STAFF RECOMMENDATION
1620 Russell Street
August 15, 2018

Application: New Construction—Addition; Partial Demolition
District: Lockeland Springs-East End Neighborhood Conservation Zoning Overlay
Council District: 06
Map and Parcel Number: 08314010900
Applicant: Yancy Lovelace, Hybrid Phoenix
Project Lead: Jenny Warren, jenny.warren@nashville.gov

<p>Description of Project: Application is to construct a rear addition.</p> <p>Recommendation Summary: Staff recommends approval of the project with the following conditions:</p> <ol style="list-style-type: none">1. The siding shall be smooth in texture; and2. Staff shall approve the roofing color, the deck materials and all windows and doors; and3. The HVAC shall be located behind the house or on either side, beyond the midpoint. <p>With these conditions, staff finds that the proposed project meets Sections II.B. and III.B.2. of the Lockeland Springs-East End Neighborhood Conservation Zoning Overlay.</p>	<p>Attachments A: Site Plan B: Elevations C: Photographs</p>
--	--

Figure 1. 1620 Russell Street

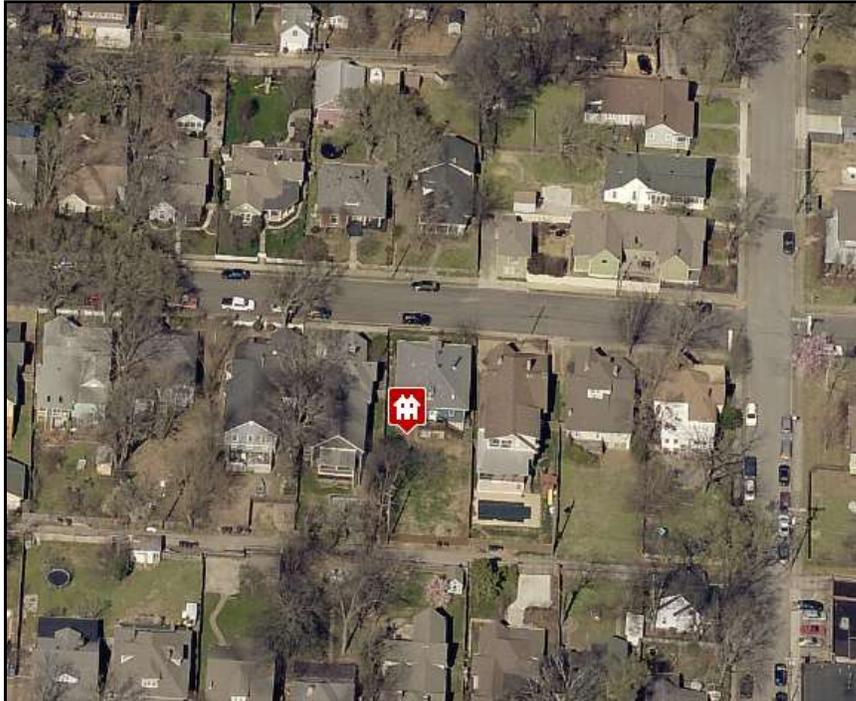
Background: 1620 Russell Street is a c. 1920 cottage that contributes to the historic character of the Lockeland Springs-East End Neighborhood Conservation Zoning Overlay (Figure 1).

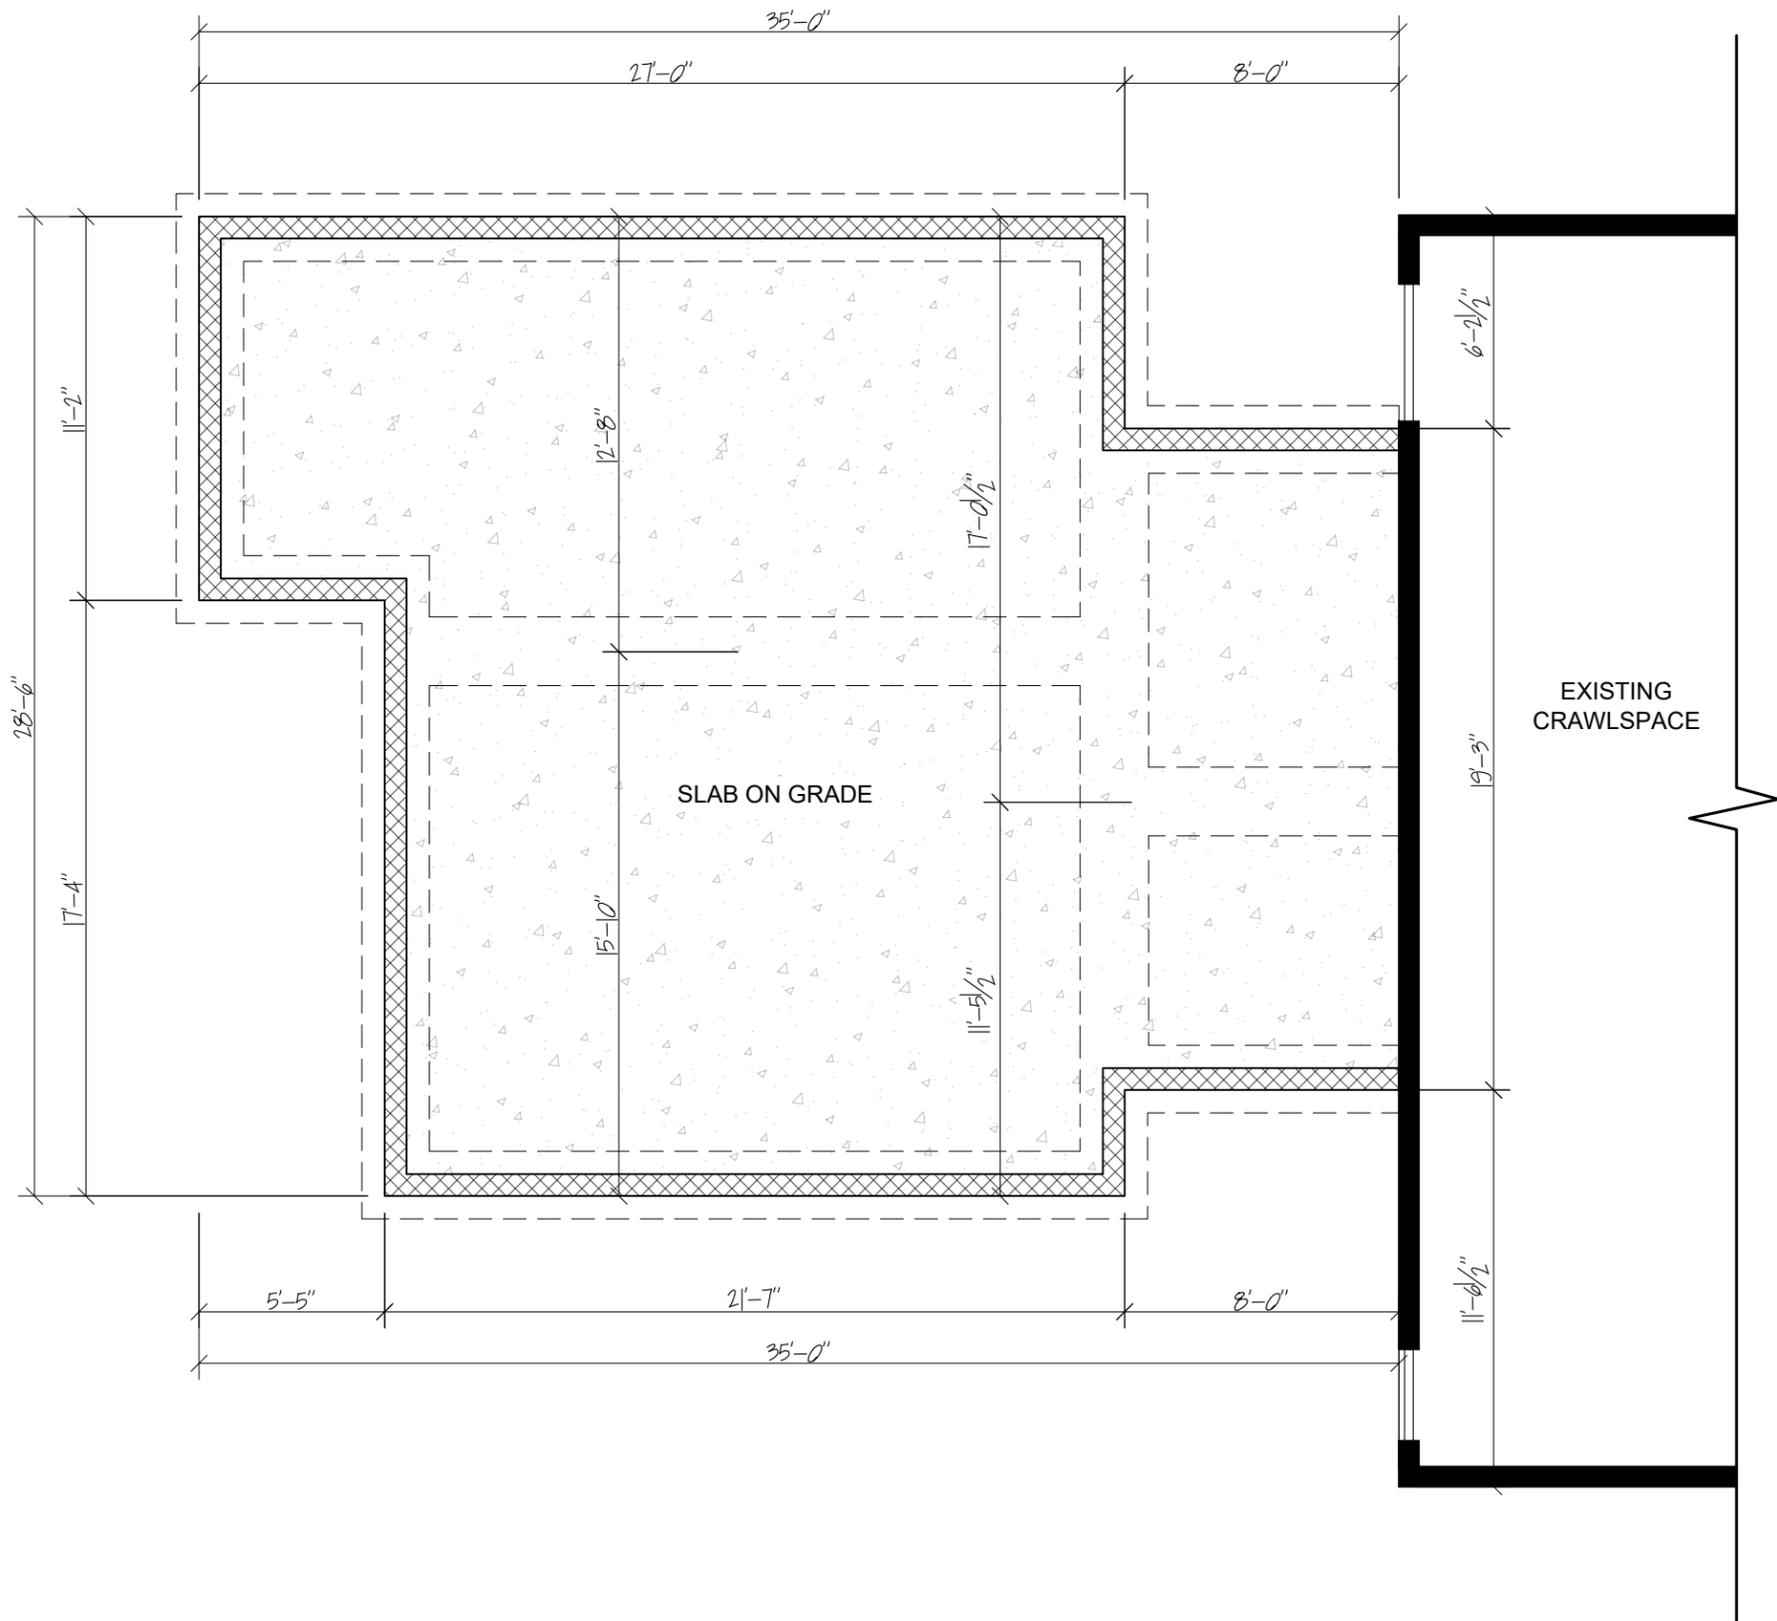
Proportion and Rhythm of Openings: No changes to doors or windows are proposed for the front or sides of the historic house. Most of the windows on the proposed addition are twice as tall as they are wide, thereby meeting the historic proportions of openings. There are two horizontal window openings on each side elevation. Staff finds these to be appropriate because: they are located on the lower level, below the foundation height of the original house; they are on the rear where they will not be highly visible; and the house has two similar horizontal windows on the west elevation, close to the street. Staff finds the project's proportion and rhythm of openings to meet Section II.B.7.

1 RIGHT ELEVATION
 A200 SCALE: $\frac{3}{16}$ " = 1'-0"

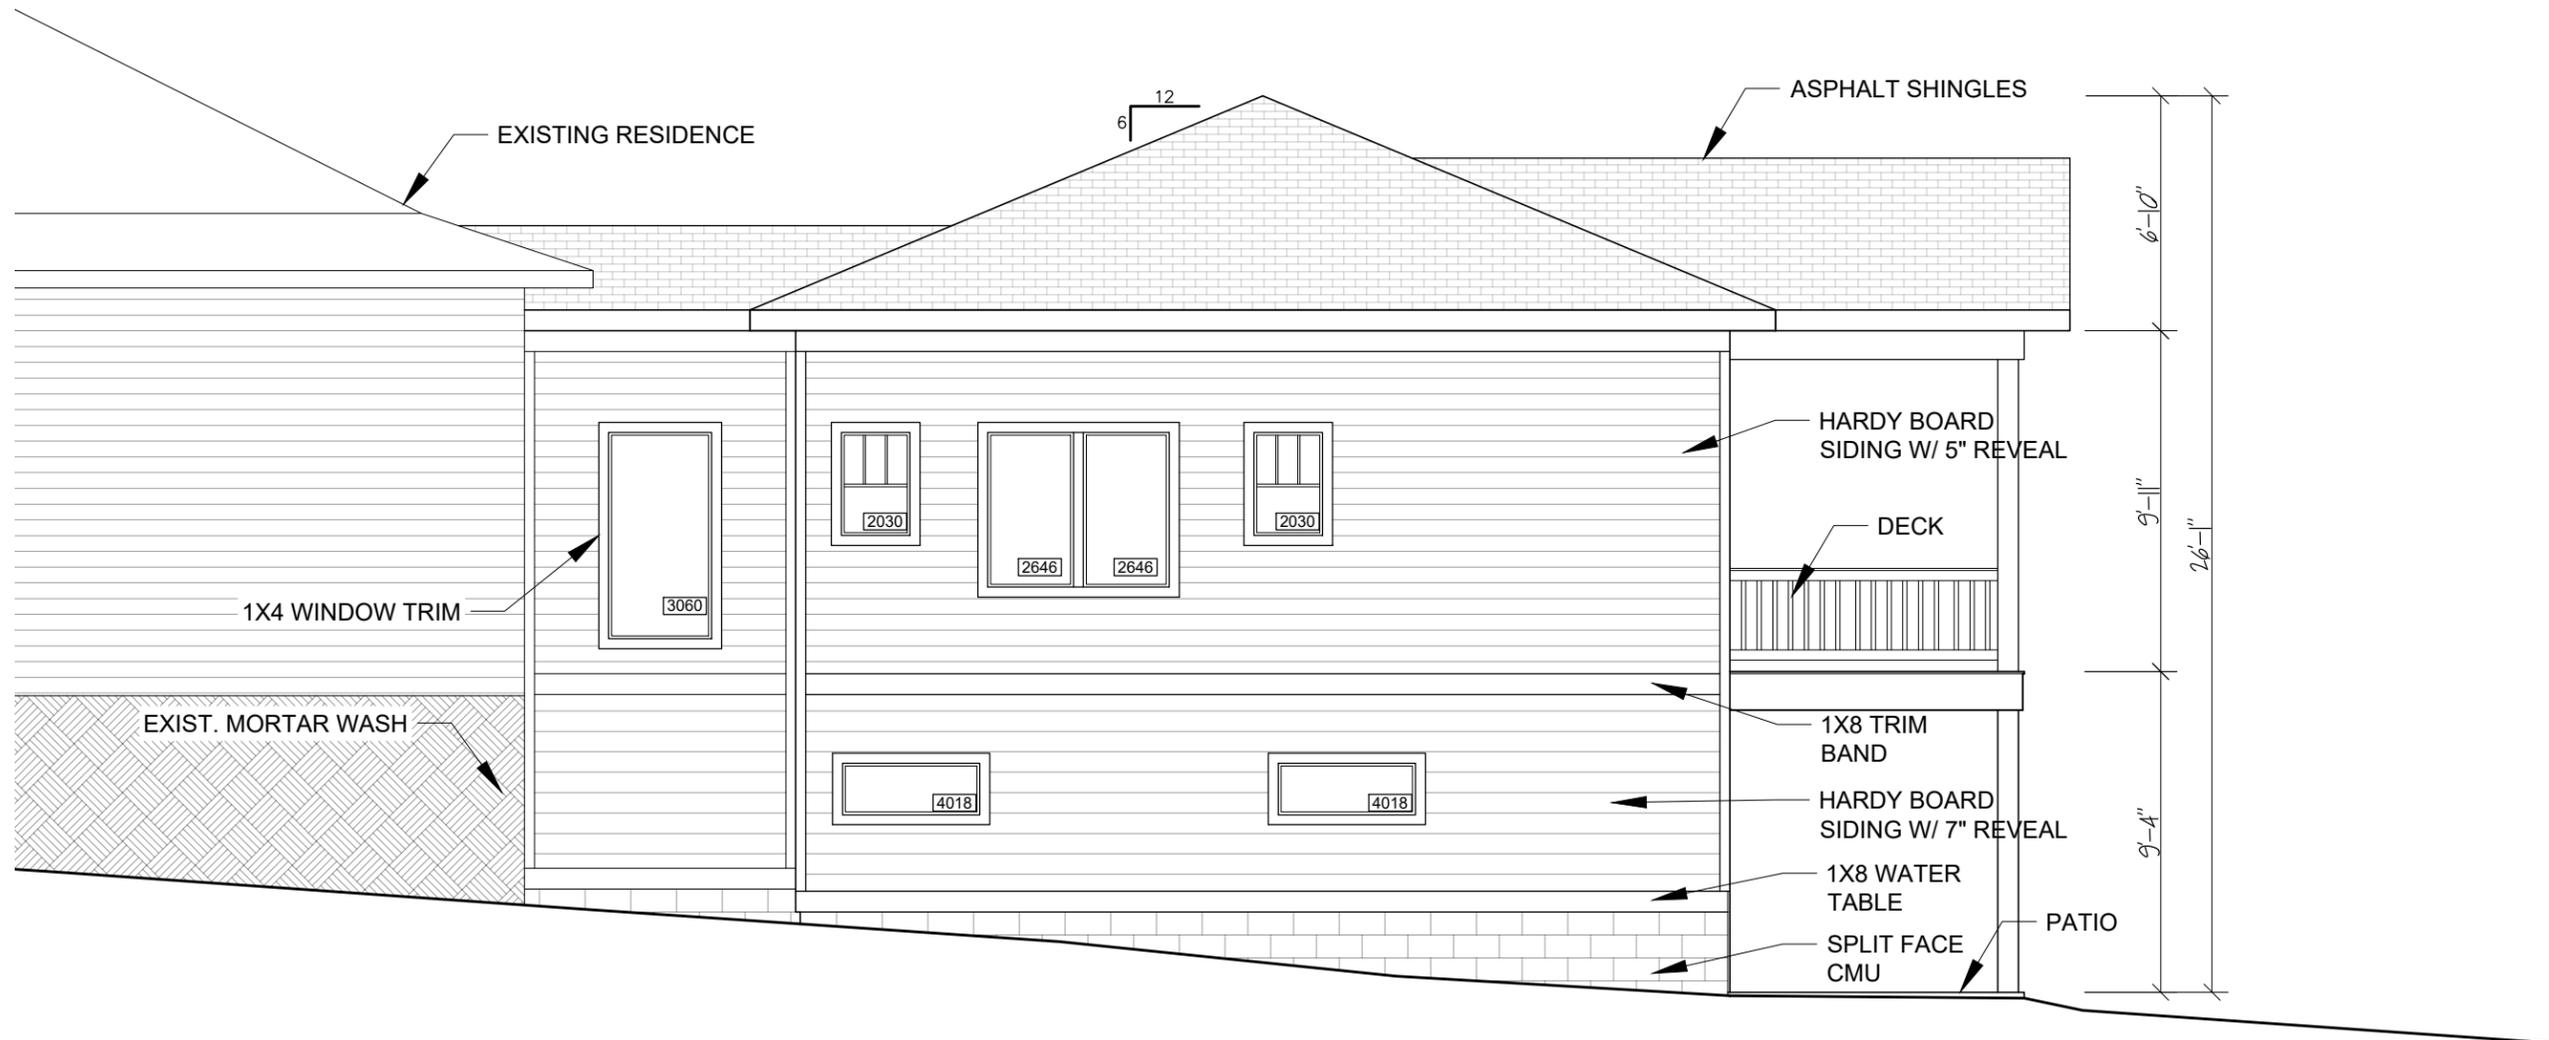
The addition is connected to the historic house via a narrow hyphen. The connector is eight feet (8') deep and is inset eight feet (8') from the west wall and eleven feet, six inches (11'6") from the east wall. Beyond the connector, the west elevation steps back out flush with the west wall of the historic house, while the east wall steps out three feet (3'), remaining more than eight feet (8') inset from the original side wall of the house. A five foot, seven inch (5'7") wide second level deck is proposed along the recessed east wall. Staff finds the width of the proposed addition to be appropriate, as it is narrower than the existing house.

Beyond the texture, the applicant is proposing siding with a five inch (5”) reveal on the second floor (level with the main floor of the historic home), and a seven inch (7”) reveal below a trim band, on the lower floor to help differentiate the floor levels (Figure 3). Staff finds this use of accent material to be appropriate.

1. The siding shall be smooth in texture; and
2. Staff shall approve the roofing color, the deck materials and all windows and doors; and
3. The HVAC shall be located behind the house or on either side, beyond the midpoint.
